Request For Information

RFI-081

Subject: BP3 Future Bld B HW/CW Accommodations
Project: Steamboat - BV BP Promenade and Goldwalk
Address: 2305 Mount Werner Circle
Steamboat Springs CO 80487 USA
Phone:
To: Zach Ray
MTech Mechanical Technologies Group, Inc.
From: Saunders Construction, LLC Alec Hallman

Through the iterative design process, running the HW and CW lines as noted in RFI-044 may cause conflict with future building B design. Per coordination meeting 9/10, the lines are to be stubbed out and capped in the locations noted in the attachment.

Description
PROMENADE - MECHANICAL SITE PLAN

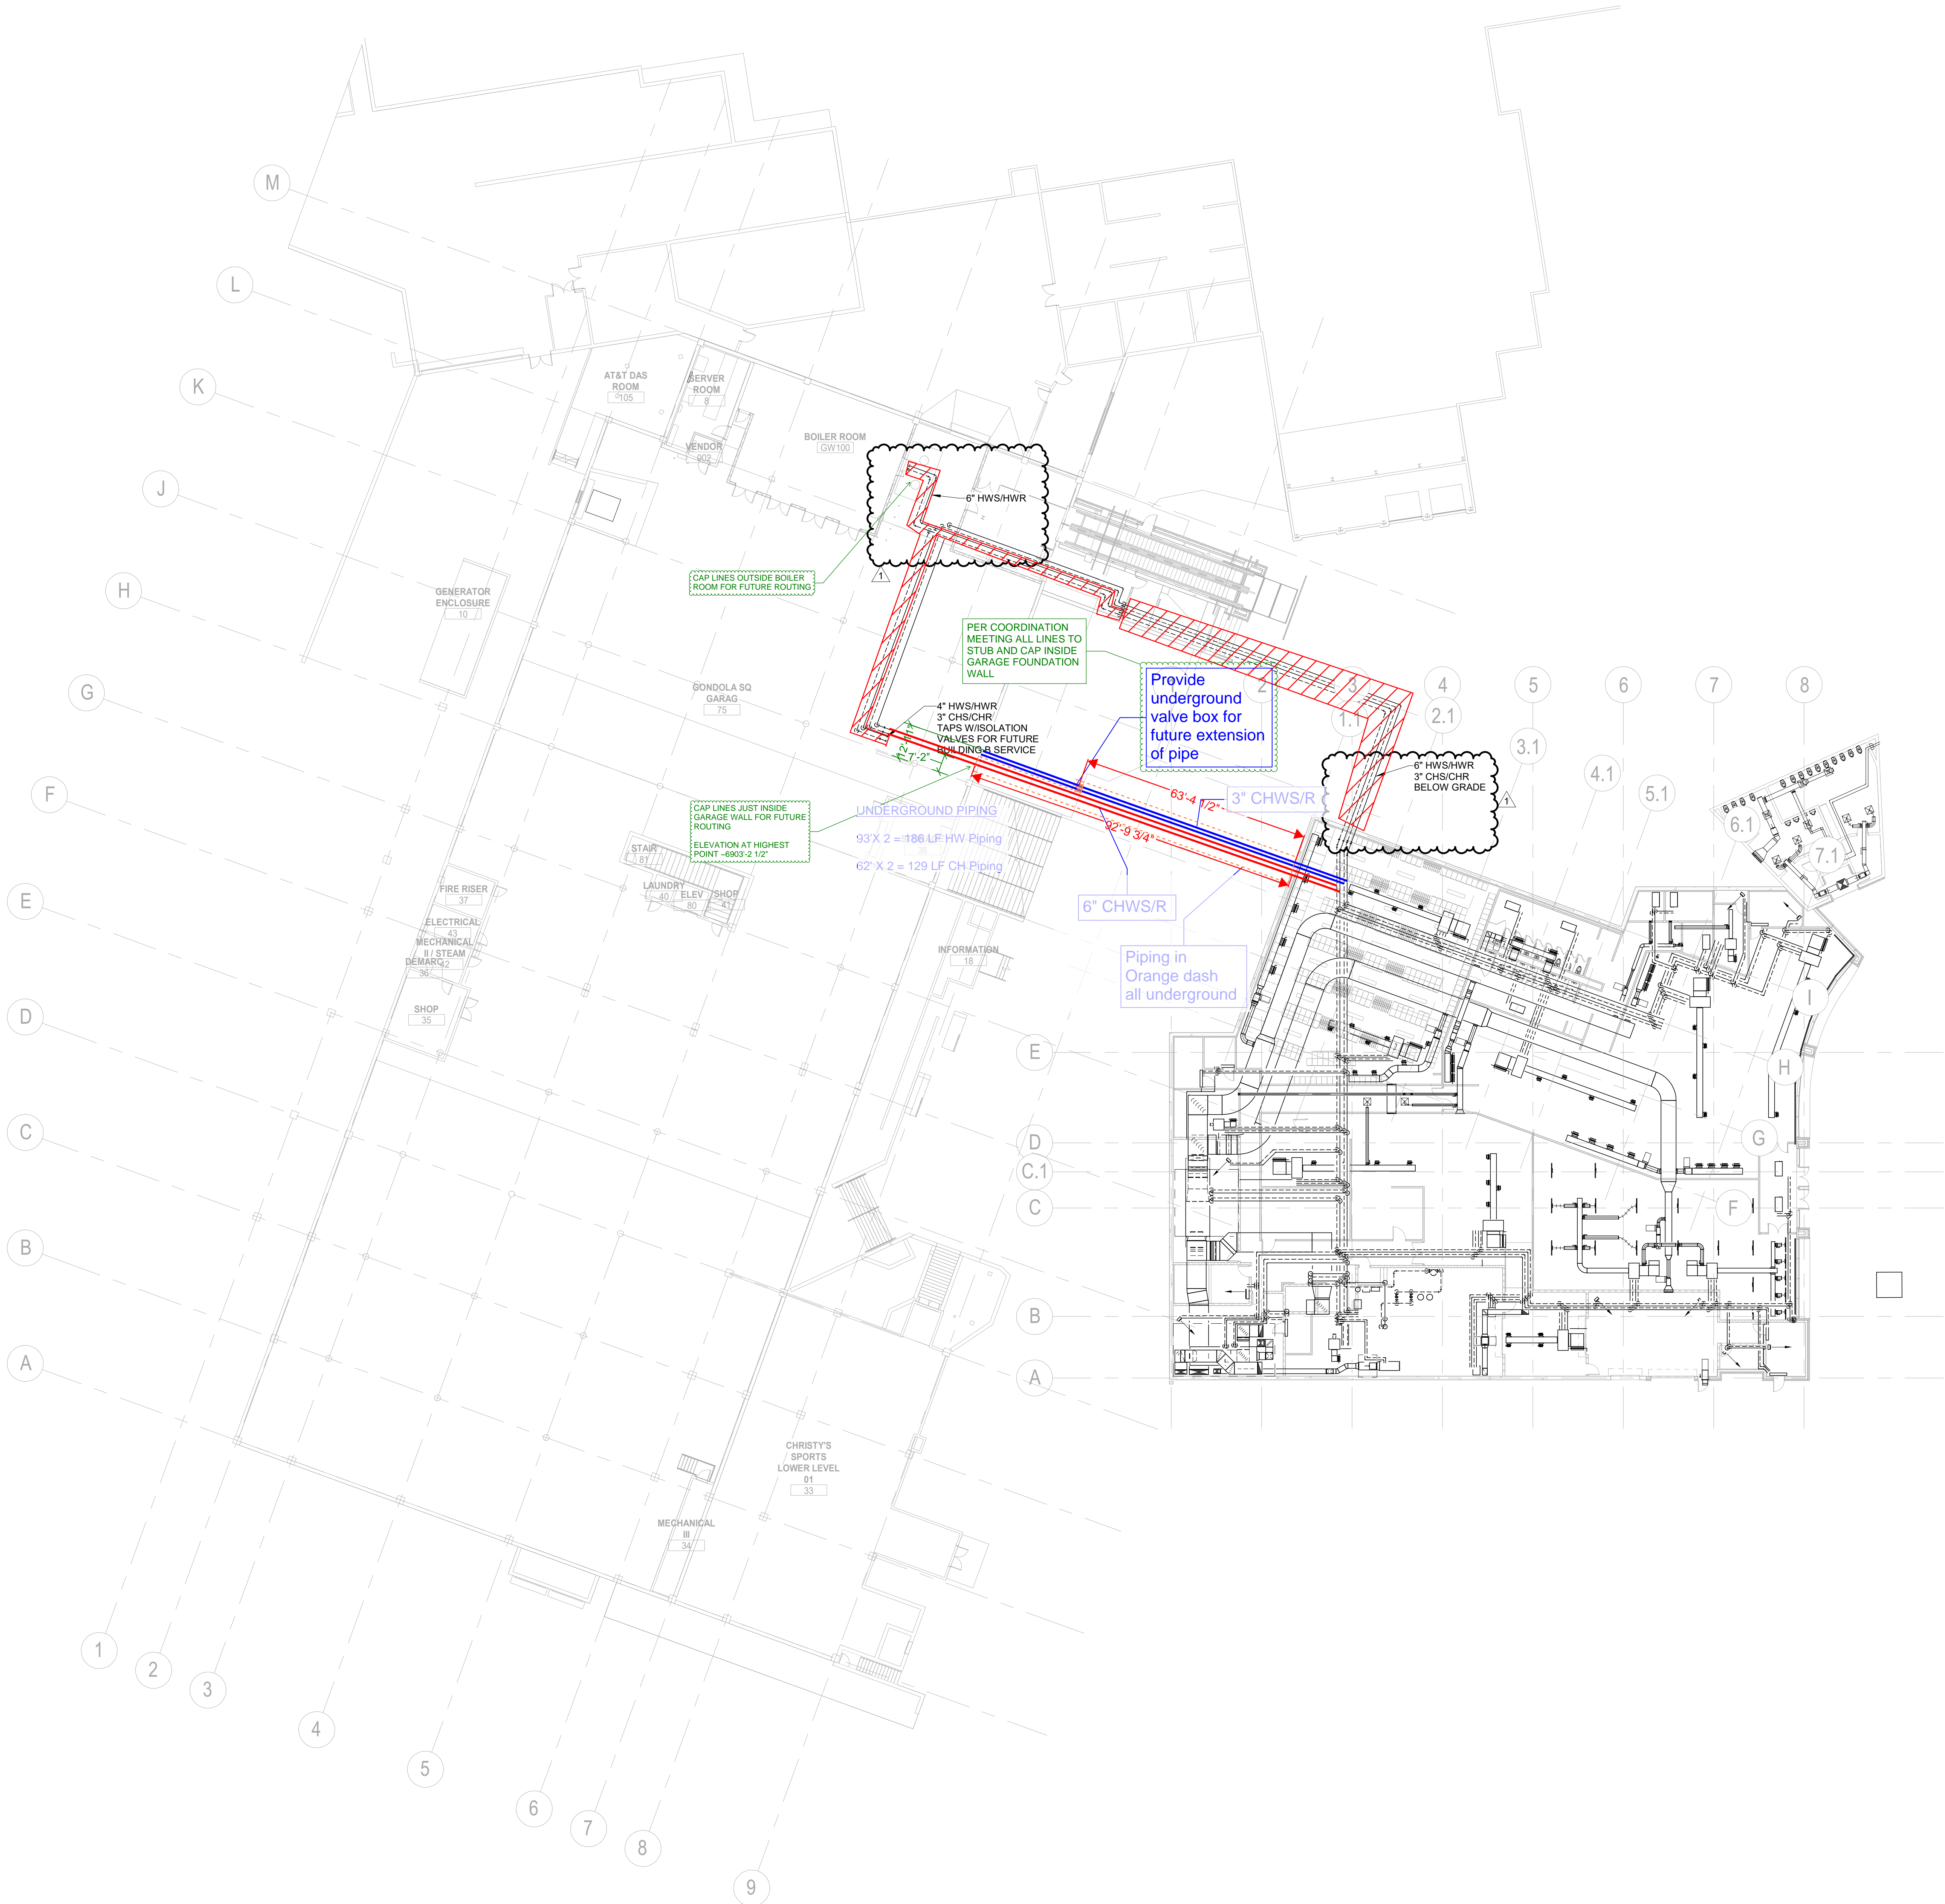
Please confirm.

CONFIRMED
Please see the attached for the revised mechanical drawings for Promenade and Gold Walk per coordination meeting on 9/10.
Evan Lukens - ME Engineers - 9/16/2021

1A-M1.200

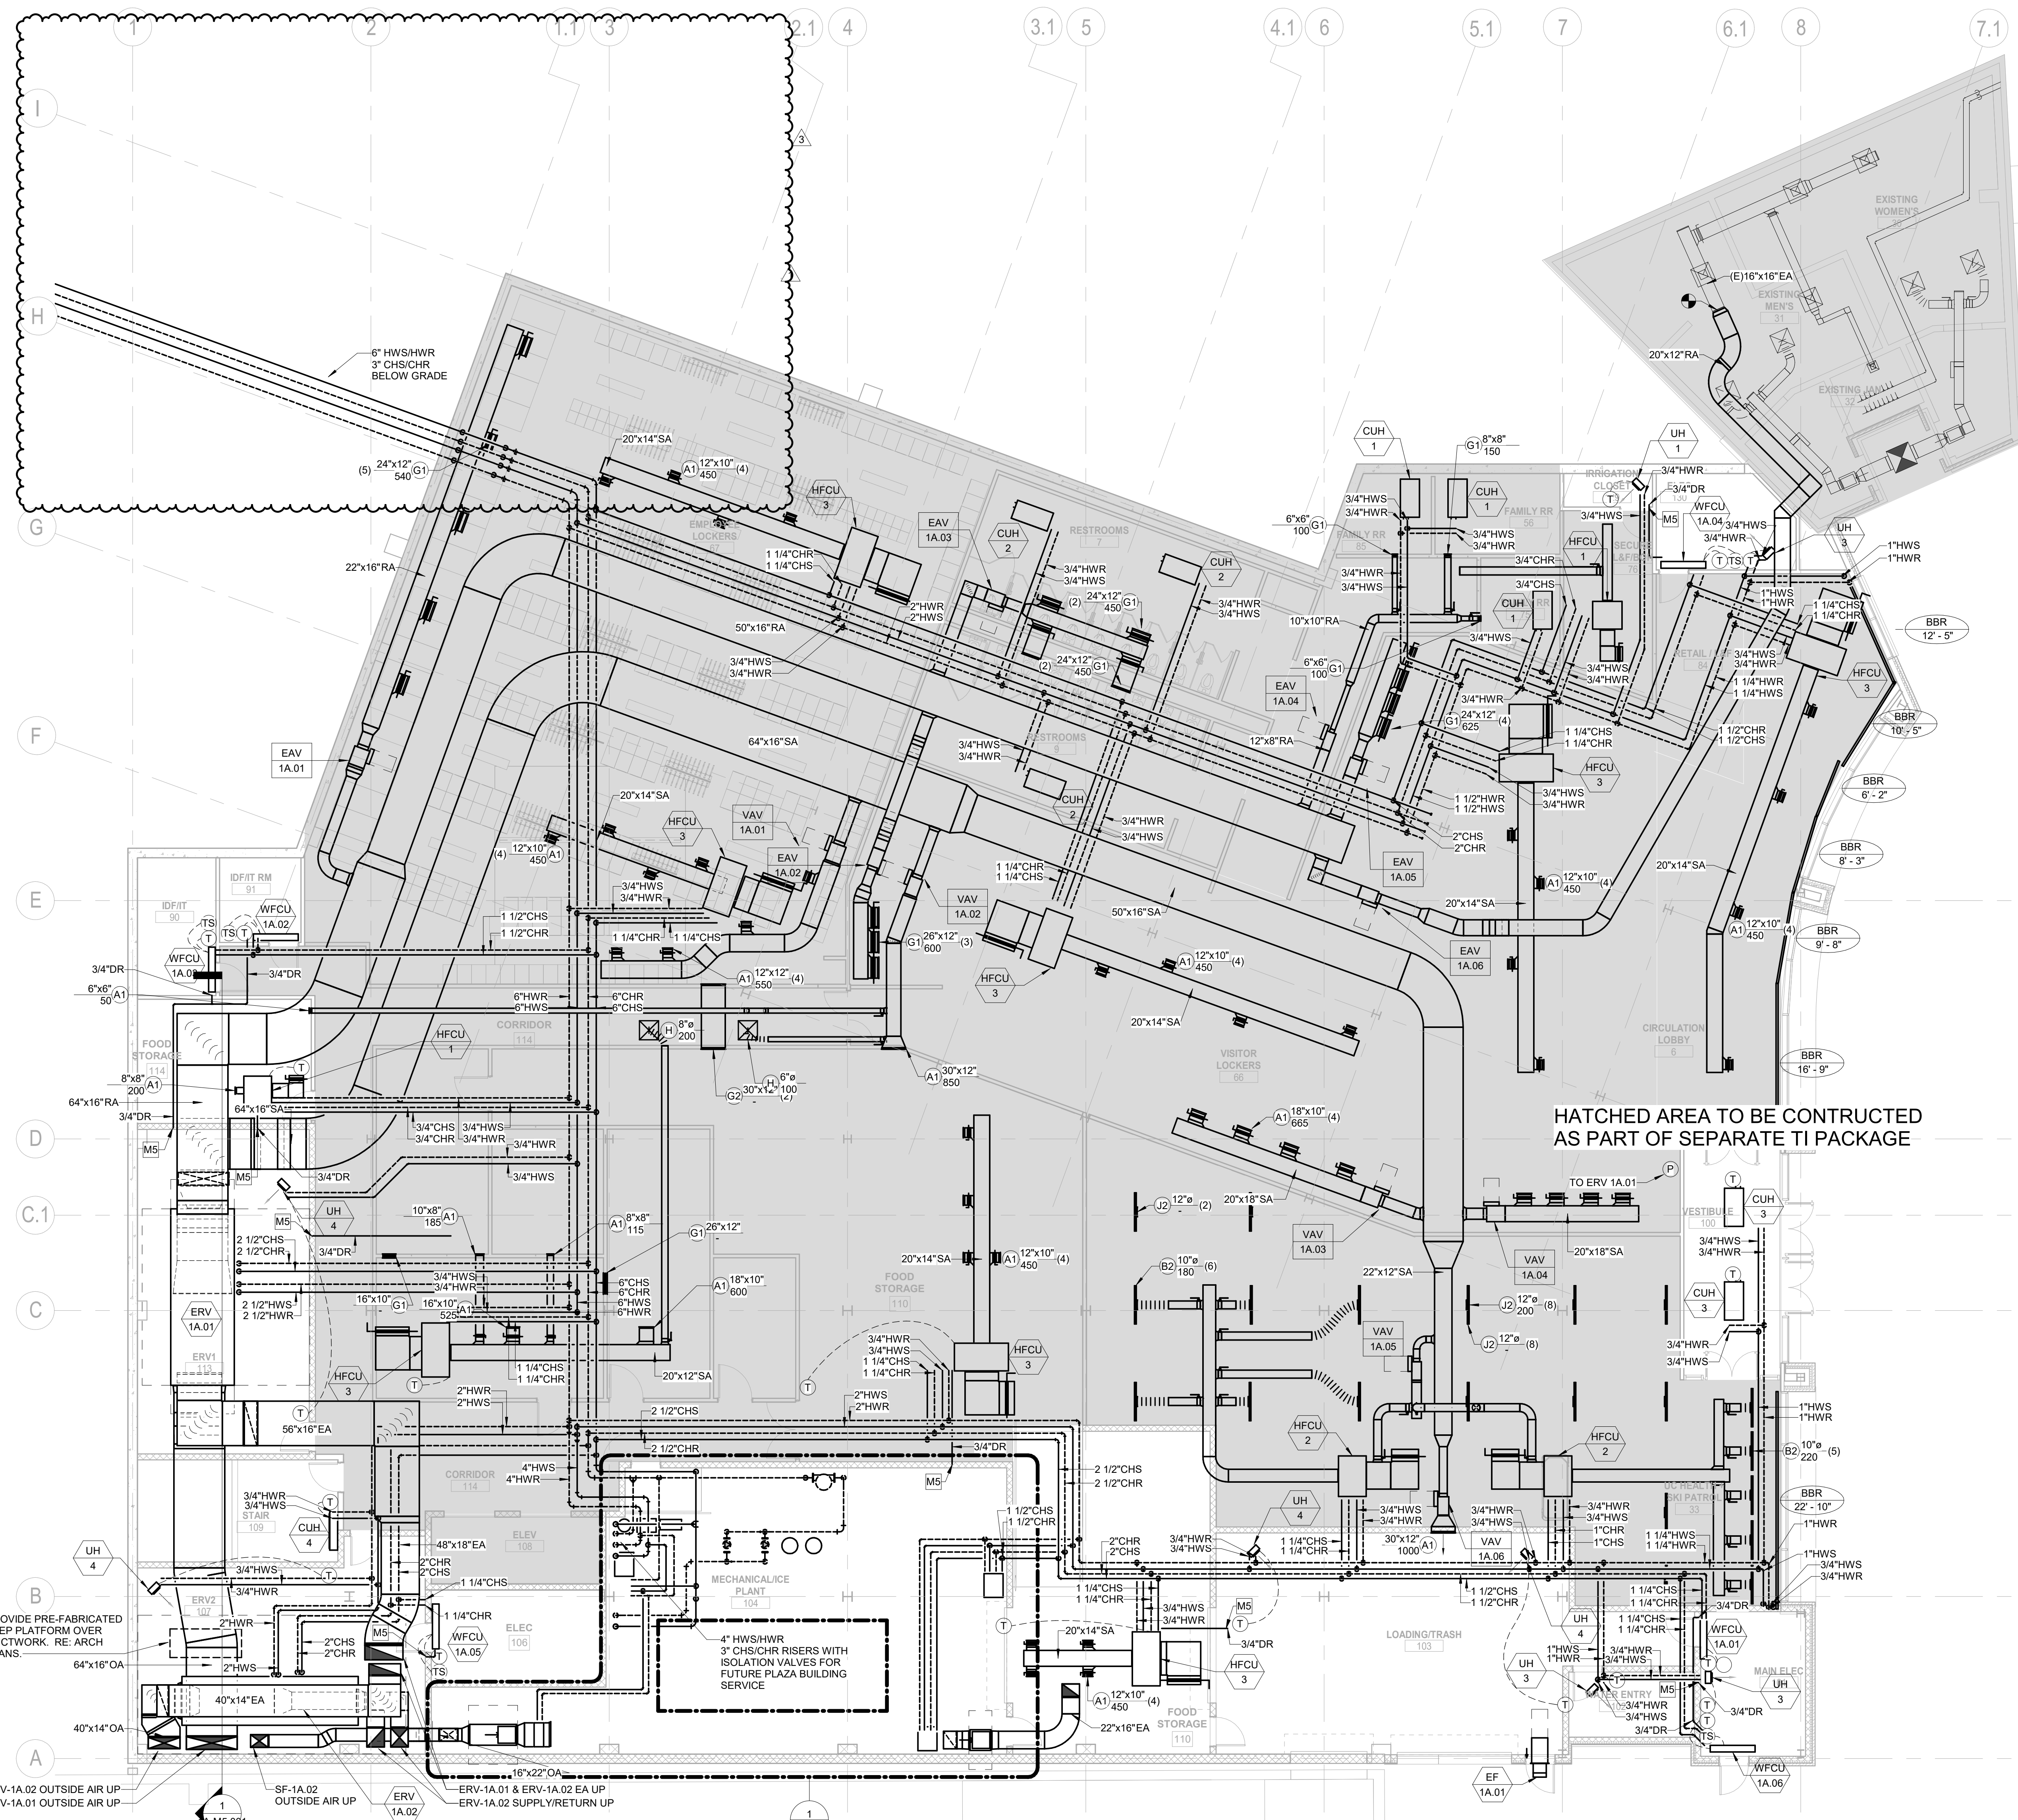
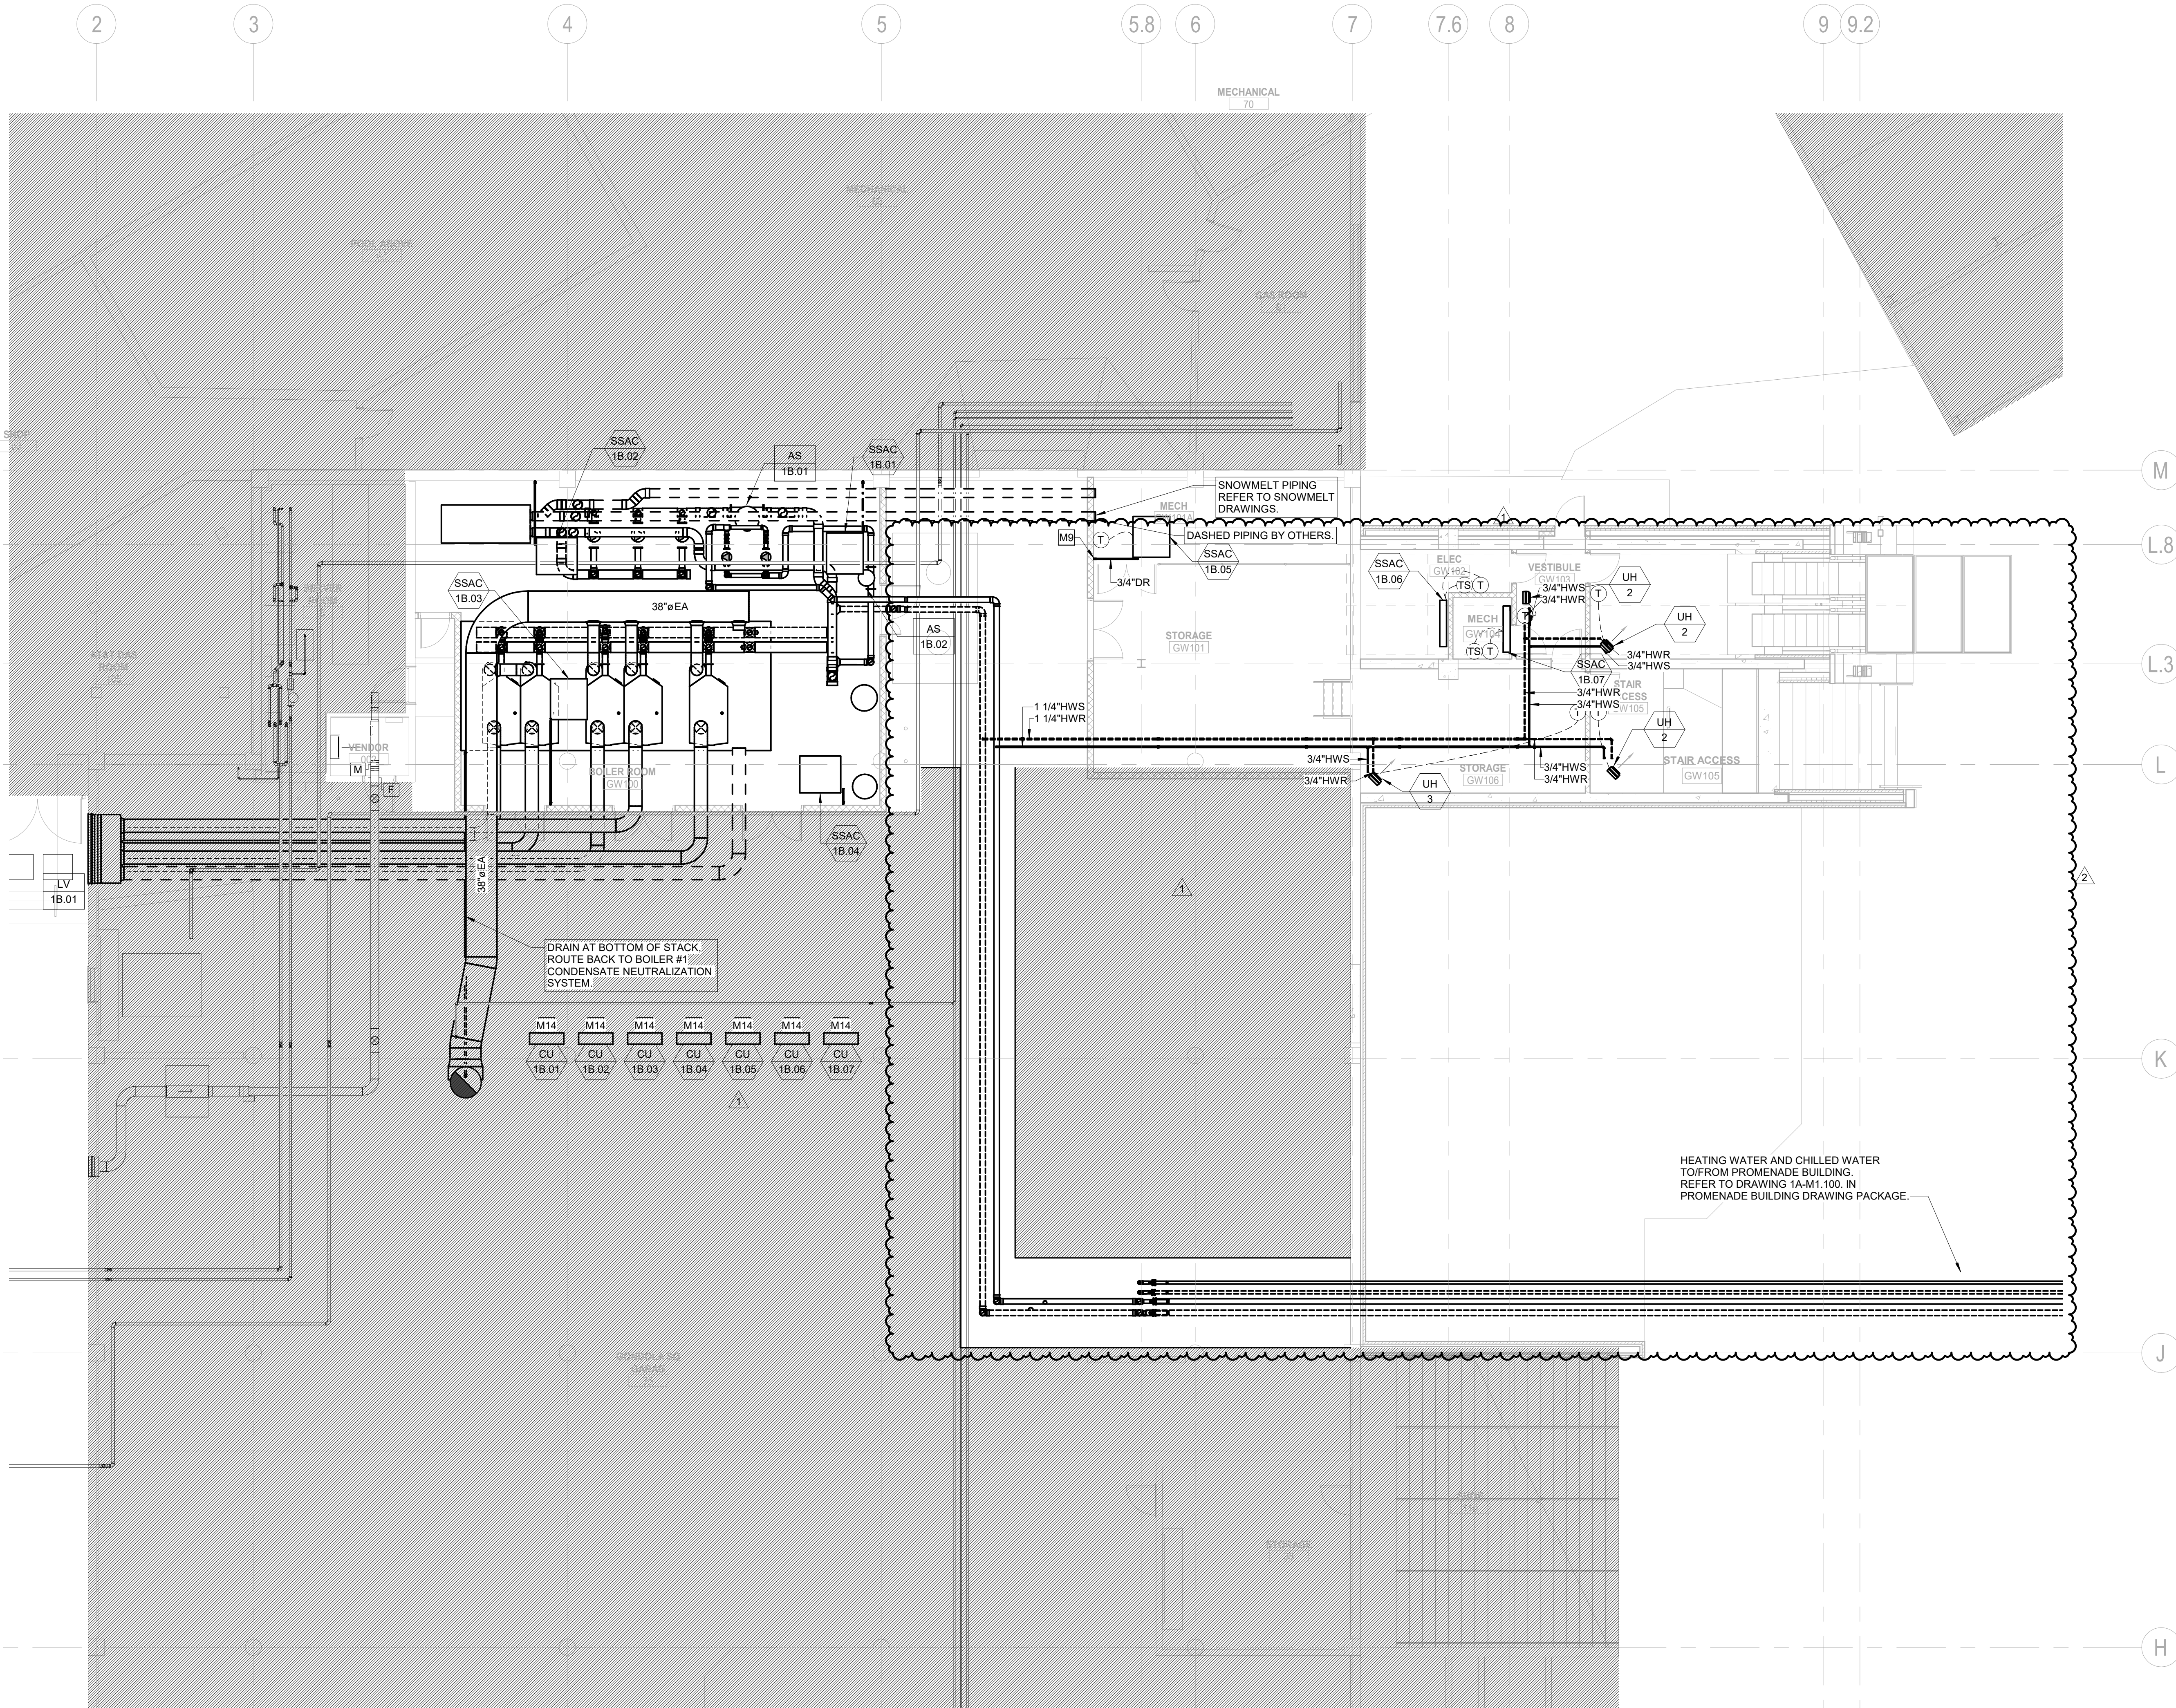
Through the iterative design process, running the HW and CW lines as noted in RFI-044 may cause conflict with future building B design. Per coordination meeting 9/10, the lines are to be stubbed out and capped in the locations noted in the attachment.

Please confirm.

Please see the attached for the revised mechanical drawings for Promenade and Gold Walk per coordination meeting on 9/10.
